Technical Memorandum

PLANS AND DOCUMENTS
referred to in the PDA
DEVELOPMENT APPROVAL

Ref: 16-002518-WTM02-Rev3

Subject: Covella - Water Precinct Network Plan Amendments

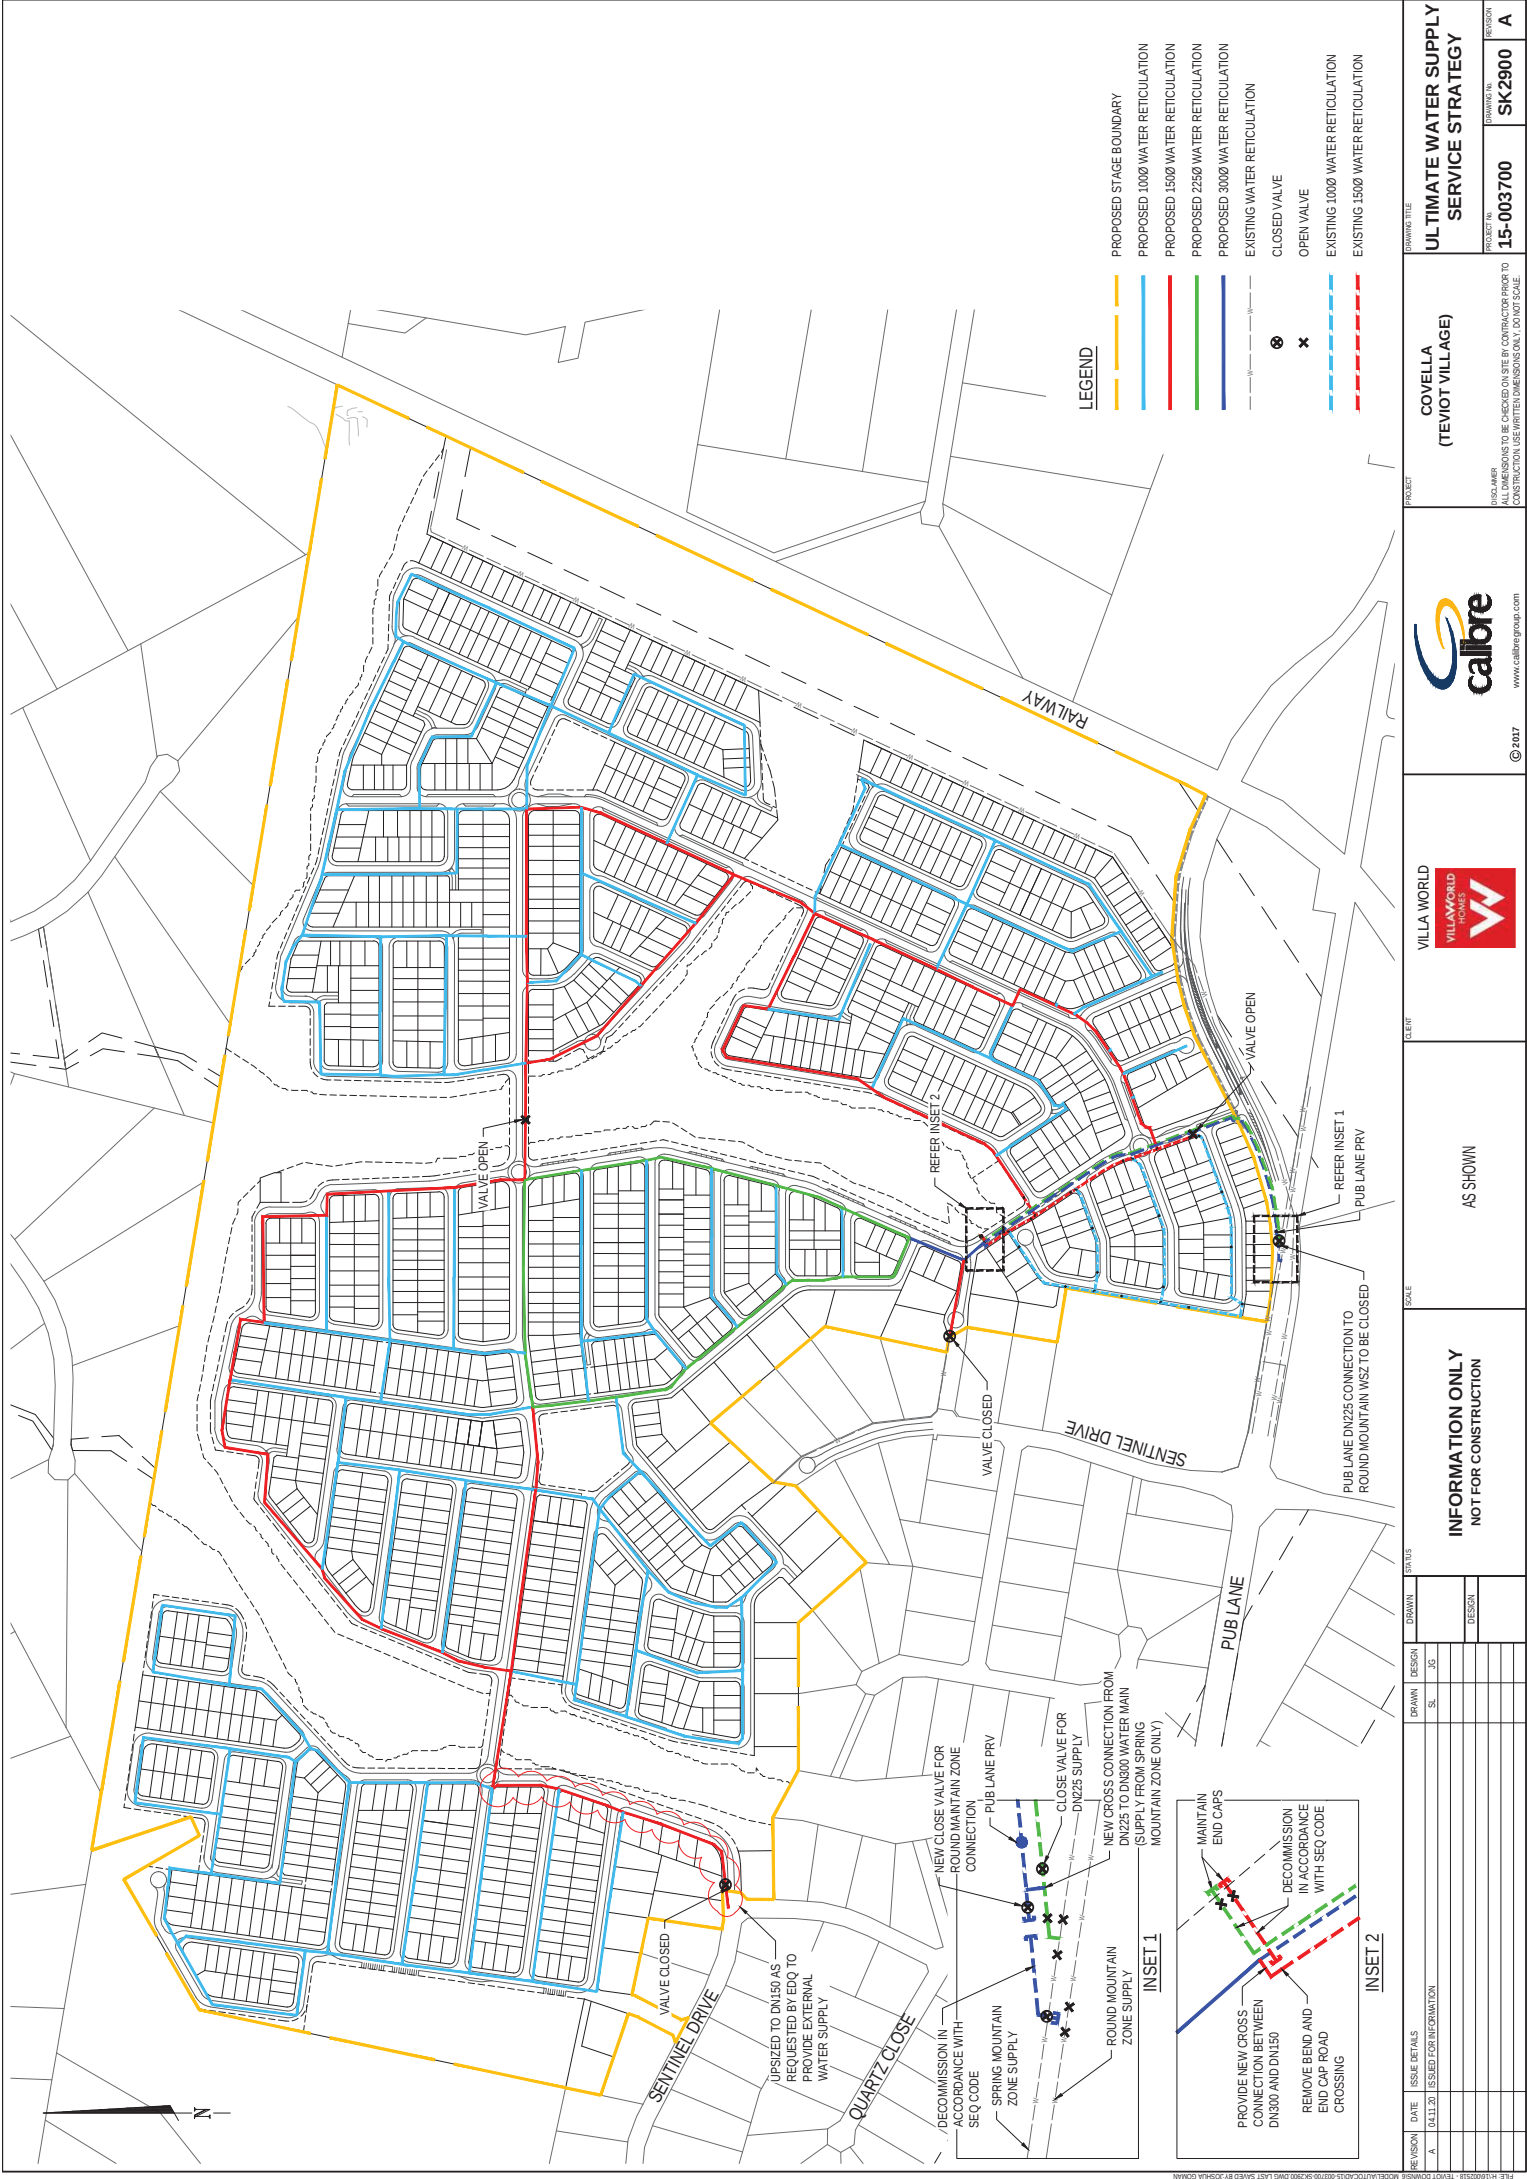
The revised network configuration is illustrated on Drawing No. 15-003700-SK2900 enclosed within Attachment 1. To service the development via the Spring Mountain WSZ only, existing boundary valves will be opened, and cross connections made between the two constructed supply mains. It should be noted that the existing Pub Lane Pressure Reducing Valve (PRV) will remain operational with cross connections between the two supply mains made after the PRV.

At the time of reporting, the current development demand is 979.1 EP which is greater than the 543.2 EP previously adopted for the interim development phase. To provide additional water supply capacity for future external development, EDQ have requested that a length of proposed DN100 water main be upsized to DN150 as shown on Drawing No. 15-003700-SK2900 enclosed within Attachment 1. Other than the changes proposed to the supply zone and upsized length of pipe, there have been no significant changes to the development layout and associated demands. Subsequently there has been little change to the updated internal network pressures outlined in Table 1.

- EDQ and Logan Water endorse the proposed internal water servicing amendment outlined within this memo and update Offset Works in accordance with Drawing No. 15-003700-SK01 within Attachment 3.
- Adopt the revised water network configuration in accordance with amended drawings included within Attachment 1 & 2.
- Verify network boundary conditions and confirm modelling assumptions prior to further detailed design.

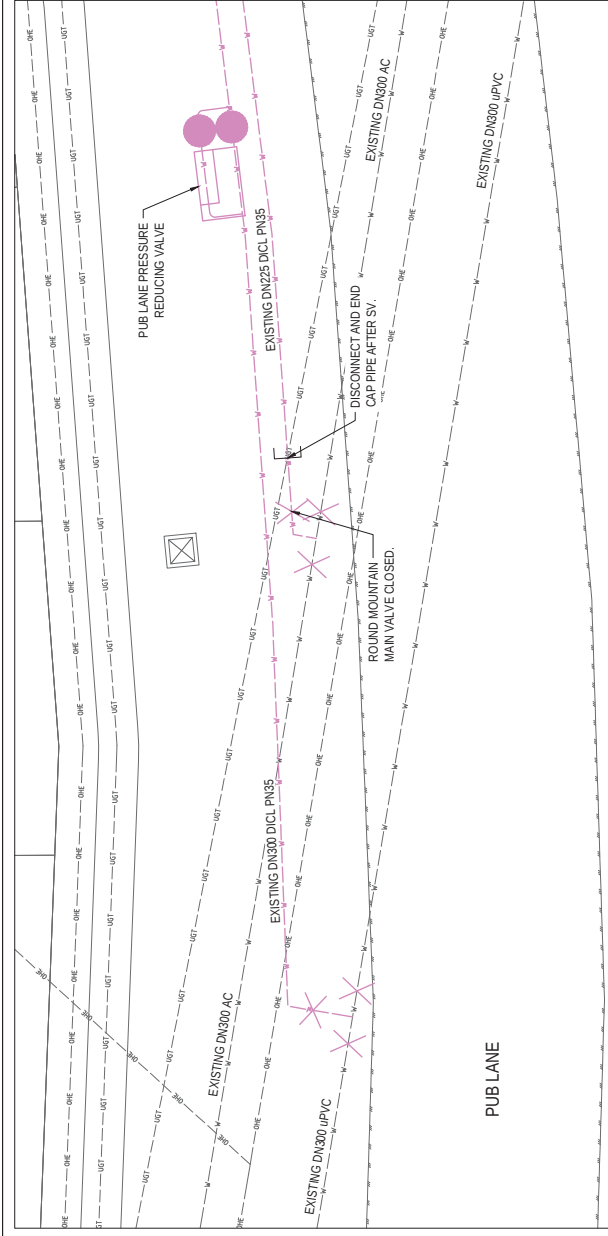
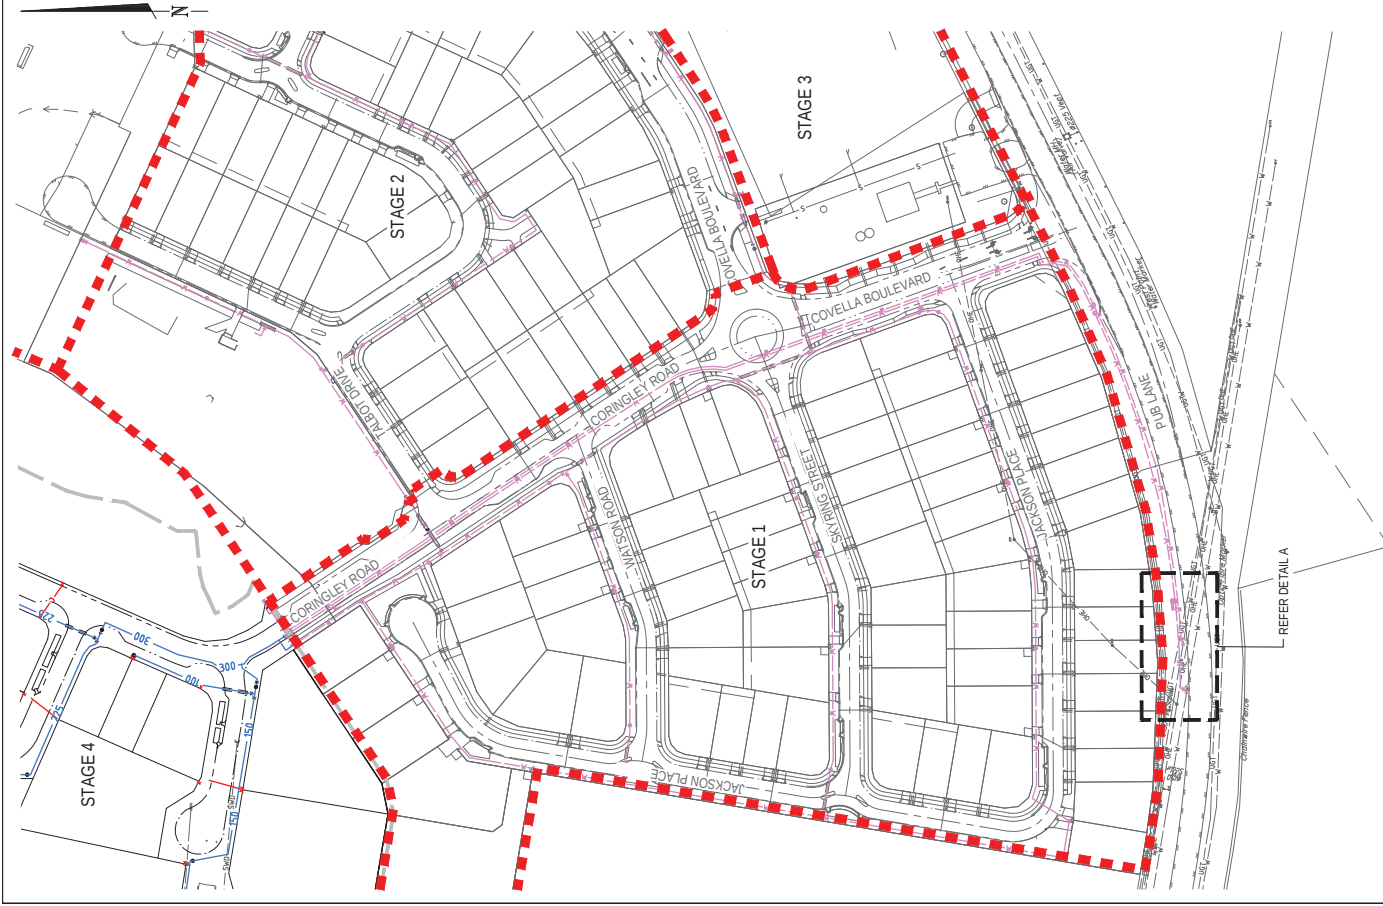
The proposed reconfiguration of exiting water supply infrastructure is illustrated on Drawing Nos. 18-000185-600, 602 and 610 included within Attachment 2. It is proposed that the existing DN300 (DICL) and DN150 (PVC-M) water mains will remain operational with a new cross connection provided at the boundary of Stage 4. The existing DN225 (DICL) water main will be disconnected and decommissioned with cap ends installed. Considering the age and material of this existing asset, Calibre recommend against grout filling the pipeline as it may offer an opportunity for future reuse as a service conduit or similar.
